May 1, 2017

RE: National Air & Space Museum Environmental Assessment

Figure 1. Section of the proposed north entrance with the 5'3" planting bed and 12' walkway highlighted.

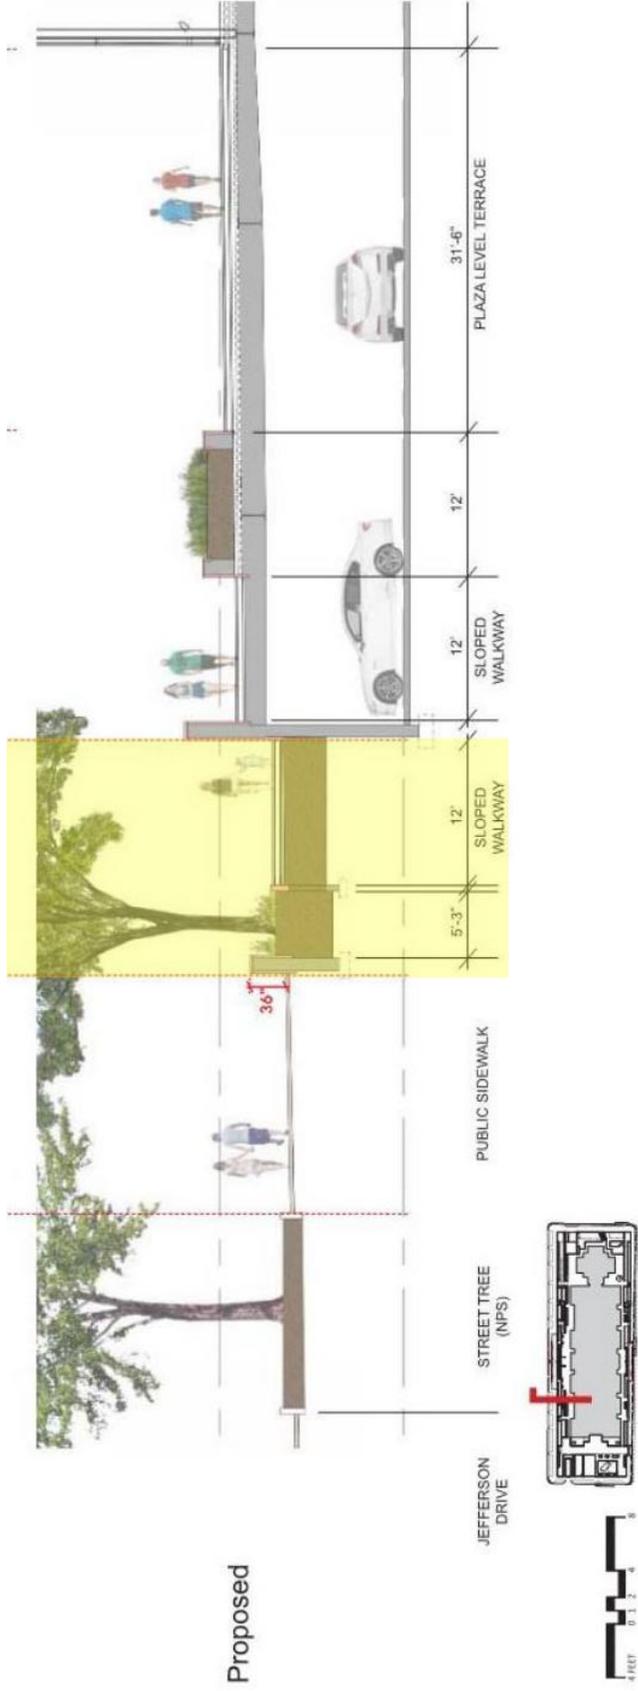
1. **Replace the tree canopy lost during construction:** The National Air and Space Museum is home to approximately 250 trees. These trees provide a lush, shady space for visitors. To maintain the environmental benefits associated with the museum’s extensive tree canopy, provide adequate tree protection fencing around the grove of trees north of the Delta Solar sculpture, plant shade trees in all planting beds with at least 1,000 cubic feet of soil, and replace lost trees in at least a 1:1 ratio.
2. **Create a larger planting bed near the north entrance:** Expand the 5’3” planting bed in the north entrance section into the space designated as a 12’ walkway to its south. This will still allow SI and NCPC to increase the number of walkways from two to three, while providing additional space to plant trees that will offer shade to visitors and passersby (Figure 1).
